ADDENDUM VII

PURCHASE OF CONSTRUCTION SERVICES FOR WATSON FINE ARTS CENTER BLACK BOX THEATER ADDITION – ST. PHILIP’S COLLEGE RFP 2025-0070

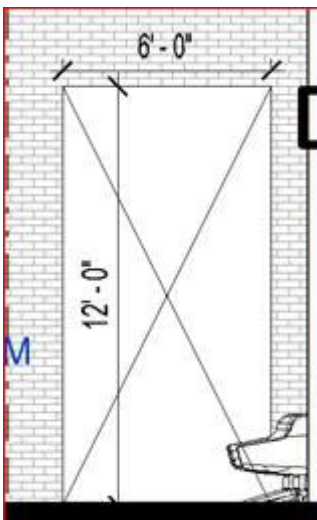
- VI. **QUESTION:** Spec Section 08 33 43 Fire & Smoke Rated Curtains and Drawing A-201, KEYNOTE 08 33 43.FSC indicate a Fire and Smoke Curtain but there are no sizes are shown. Please provide the size of the fire curtain
ANSWER: size would be 12'-0" x 6'-0" as indicated in this snippet.
